**PG&E Response to Request for Additional Information For  
 Diablo Canyon Independent Spent Fuel Storage Installation (ISFSI)  
 License Application**

**Chapter 1. Introduction and General Description**

**Chapter 2. Site Characteristics**

Figure 1 Comparison of Rock and Rock-like Shear wave velocity Profiles with Pleistocene Deposits Velocity Profile along Transport Route

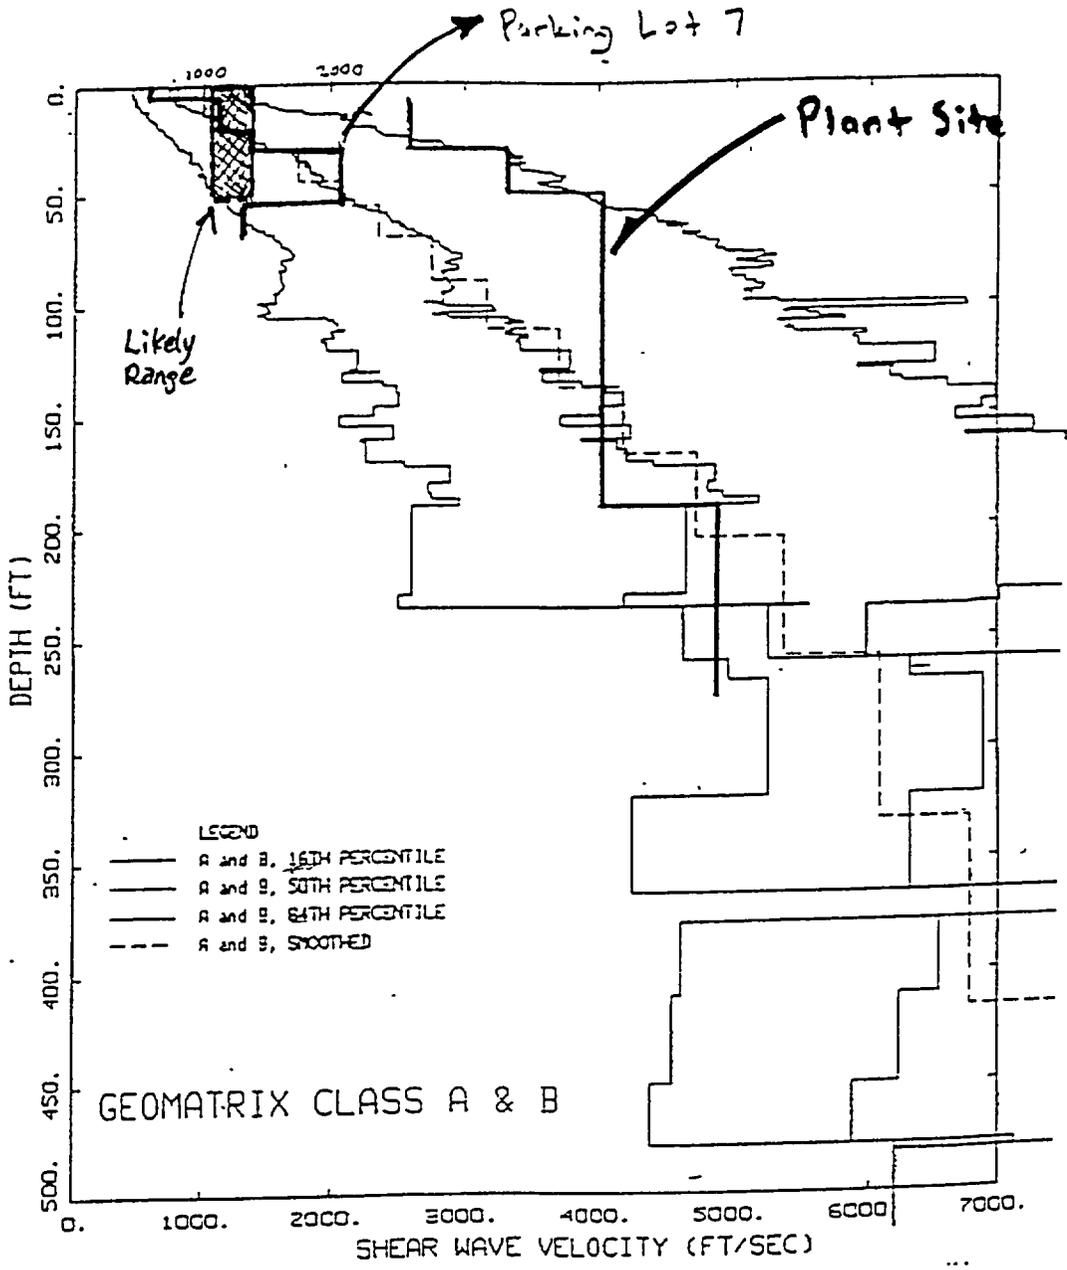
*Provide site-response assessment of the vibratory ground motions for the proposed transport route roadway between the nuclear power plant and the Diablo Canyon ISFSI pad; or provide sufficient justification of why a seismic event that may cause cask drop, overturn of the transporter, or sliding of the transporter off the transport route is not credible (as described in Section 8.2.1.2.1 of the Diablo Canyon ISFSI Safety Analysis Report).*

*Unlike the power plant and the storage-pad locations, which are founded on bedrock, the proposed transport route is underlain by soils and manmade fill. The site response of these soils and manmade fill could change the amplitude and spectral frequency content of the input vibratory ground motions used in seismic design analyses of the transporter and casks. The conclusion provided by the Applicant in Section 8.2.1.2.1 of the Diablo Canyon ISFSI Safety Analysis Report is that the limited exposure time of the radioactive material during transportation from the power plant to the Cask Transfer Facility (12 hr per year, which is equal to a yearly probability of  $1.37 \times 10^{-3}$ ), makes this a noncredible accident scenario. This conclusion requires further justification.*

The shear-wave velocity profiles of sites classified as either Geomatrix class A or Geomatrix class B which have been used in developing attenuation relations are summarized in Figure 1. This figure shows the median, 16<sup>th</sup>, and 84<sup>th</sup> percentile shear-wave profile for rock and rock-like (class A and class B) sites. Also shown on this figure is the range of velocities and depths for the Pleistocene fan deposits along the transport route and one downhole measurement in Parking Lot 7 in close proximity to the transport route. The velocities from the Pleistocene fan deposits are consistent with the velocity profiles measured at rock and rock-like sites.
